LINOTYPE IMPROVEMENT INFORMATION SHEET

NO. 336

IMPROVED DISTRIBUTOR CLUTCH

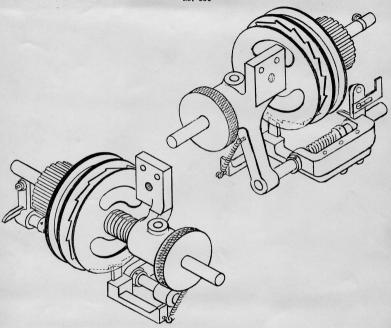
A new, much simpler and more sensitive distributor clutch has been designed for single distributor Linotypes.

The clutch is actuated by a new clutch lever which operates in conjunction with a toothed disk. If matrix travel on the distributor bar is interfered with, the lower distributor screw is moved to the left. This permits a spring to pull a stop on the clutch lever against the toothed disk to stop the rotation of the disk. This action disengages the friction facings from contact with the clutch pulley, thereby stopping the distributor.

Can be applied to outstanding single distributor Linotypes equipped with the spiral automatic distributor clutch. In ordering specify part number 38-0210-01 and give model and serial number of the outstanding machine.
